Comment (#167):

(TDL #385 D2.2)

Comment: Do we need the spec for Irms in 145.3.8.4?

Annex – A

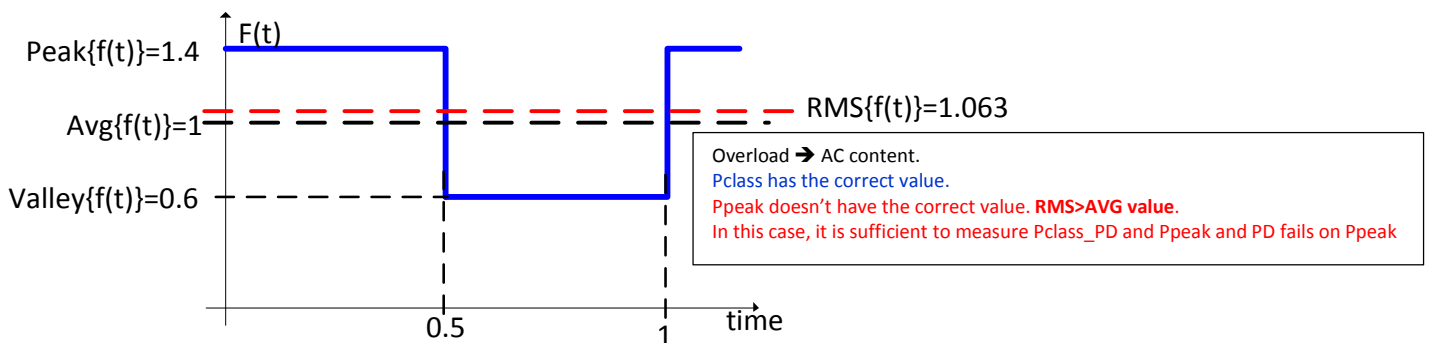
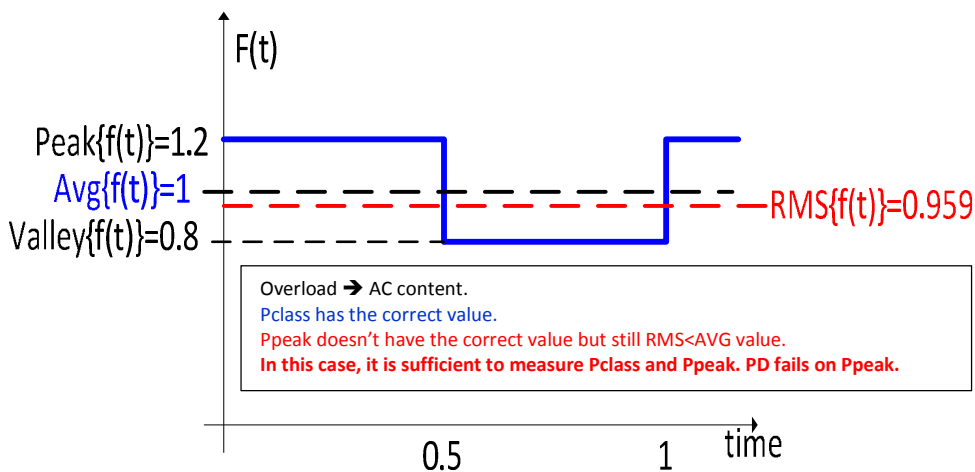
- When the Load has AC content, RMS power and the Average power are not equal.

In order to prevent excessive heat due to RMS values > AVG values we need to set a limit to the RMS value in order to guarantee that the RMS value of PClass will be the same as the average value of PClass.

PClass_rms <=PClass_average

$I_{rms} \leq I_{dc} = P_{class_PD} / V_{pd} - 2P$
